Product Change Notice (PCN)

Subject: Change in Marking Format on Select Device

Publication Date: 3/6/2023

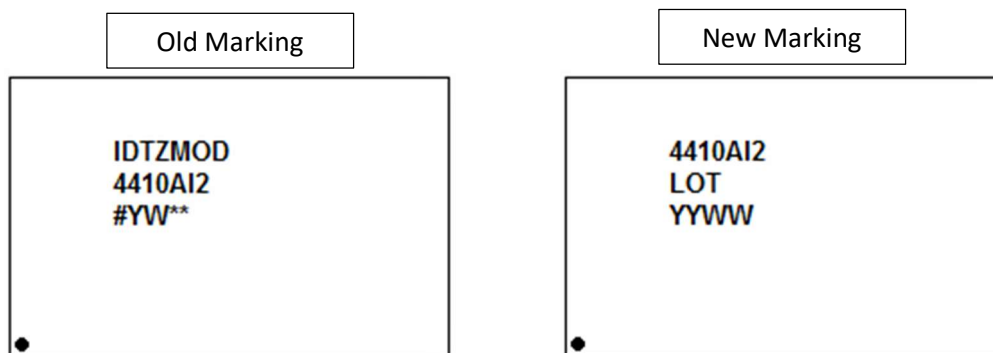
Renesas is changing the marking format on ZMOD4410AI2R and ZMOD4410AI2V to align with the AI1 version of the device as shown in the below diagram.

where Line 1: IDT + Device part number

Line 2: Device part number

Line 3: # Stepping

YW Datecode

** Lot sequence

Line 1: Device part number

Line 2: Lot number

Line 3: YYWW Datecode
